Administrative Order SWD-1879
August 13, 2020

**ADMINISTRATIVE ORDER
OF THE OIL CONSERVATION DIVISION**

Pursuant to the provisions of Division Rule 19.15.26.8(B) NMAC, Probitry SWD, LLC. ("the operator") seeks an administrative order for its McDonald South SWD No.1 ("the well") with a location of 1750 feet from the North line and 1400 feet from the East line, Unit letter G of Section 7, Township 26 South, Range 29 East, NMPM, Eddy County, New Mexico, for the purpose of commercial disposal of produced water.

WELL SCHEMATIC - PROPOSED McDonald South SWD Well No.1

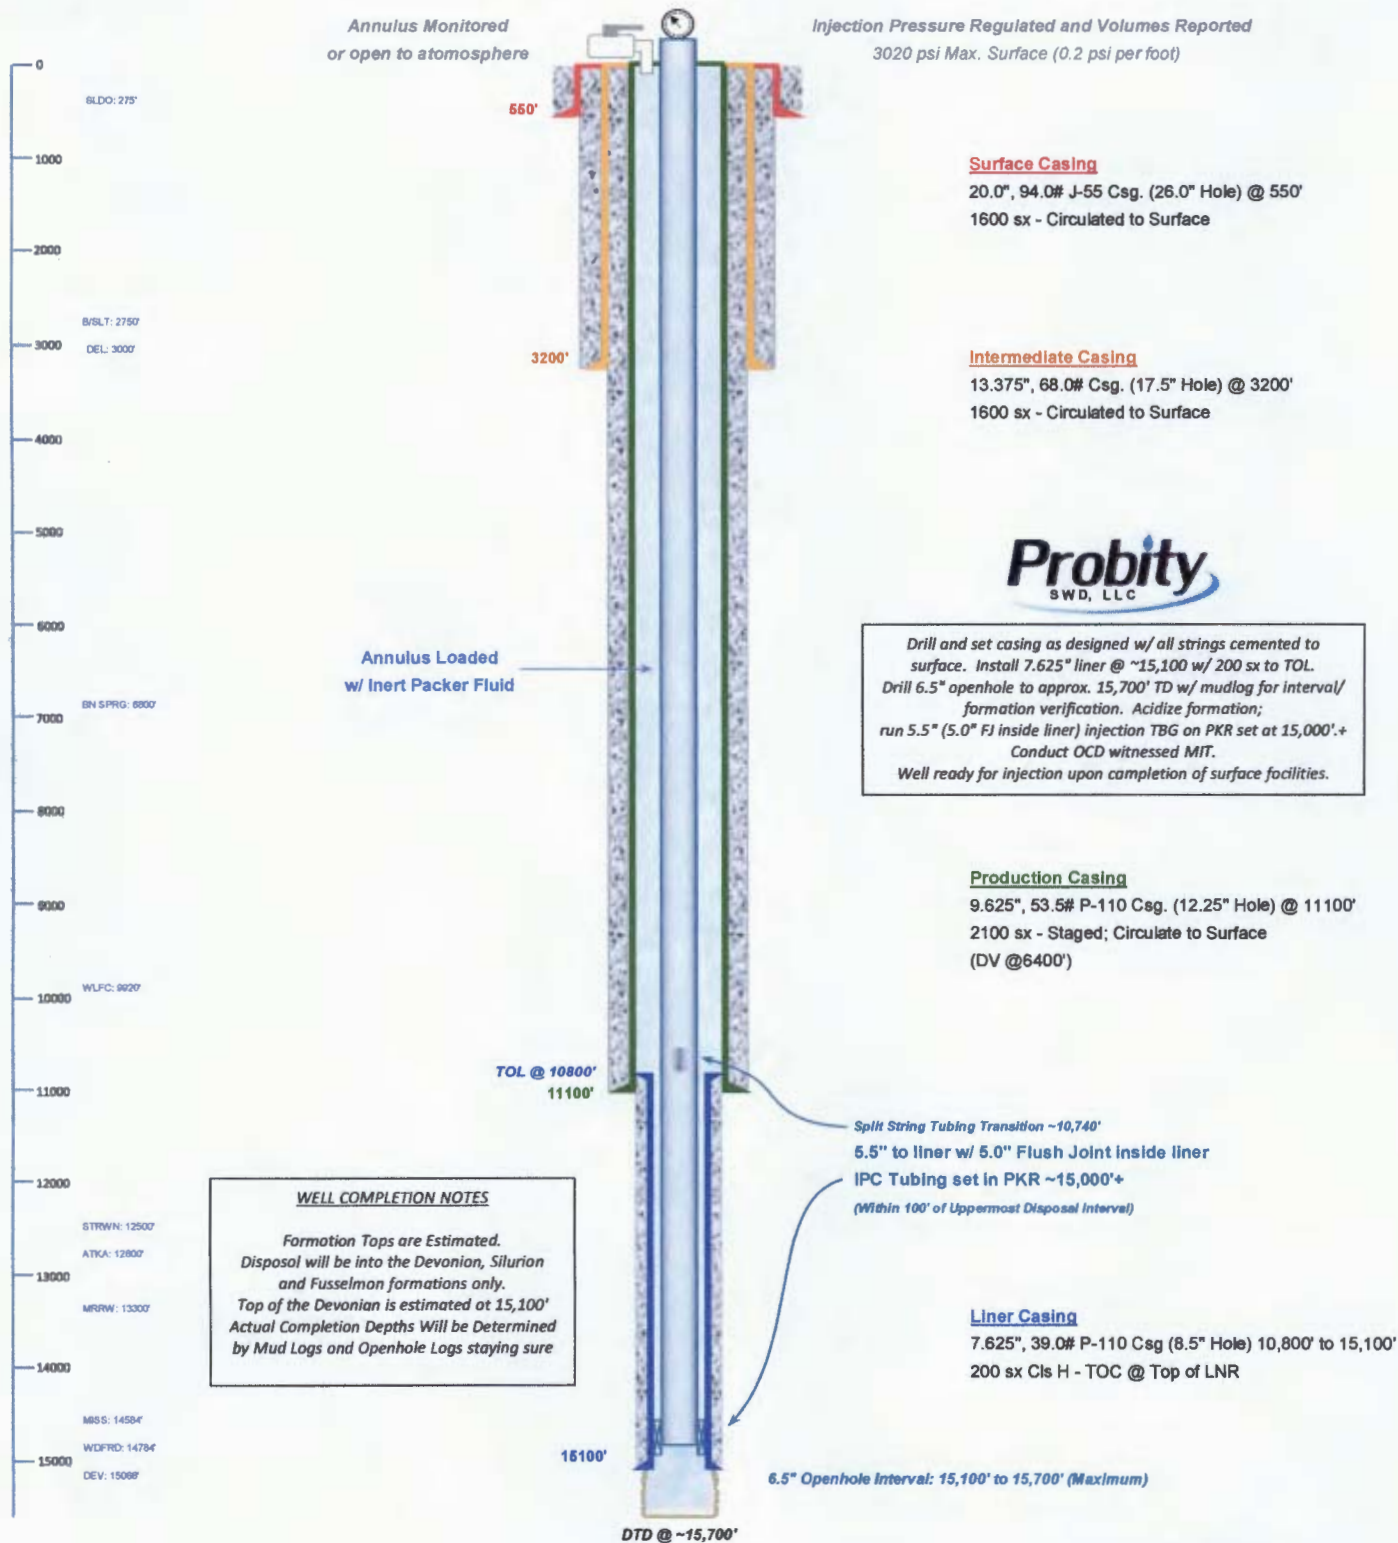
approximately 15,100 feet to approximately 15,700 feet. Injection will occur through internally-coated, 5½-inch or smaller tubing within the 9⅝-inch production casing and 5 inch or smaller tubing within the 7⅝-inch liner with a packer set within 100 feet of the top of the disposal interval. This permit does not allow disposal into:

The operator shall set surface casing 25 feet below the top of the Rustler anhydrite in order to seal off protectable water.

The operator shall circulate to surface the cement for the 9⅝-inch production casing.

The operator shall run a CBL (or equivalent) for the 7⅝-inch liner to demonstrate the placement of cement and the cement bond with the tie-in with 9⅝-inch production casing string. The operator shall provide a copy of the CBL to the Division's District office prior to commencing disposal.

The wellhead injection pressure on the well shall be limited to **no more than 3,020 psi**. In addition, the disposal well or system shall be equipped with a pressure limiting device in workable condition which shall, at all times, limit surface tubing pressure to the maximum allowable pressure for this well.
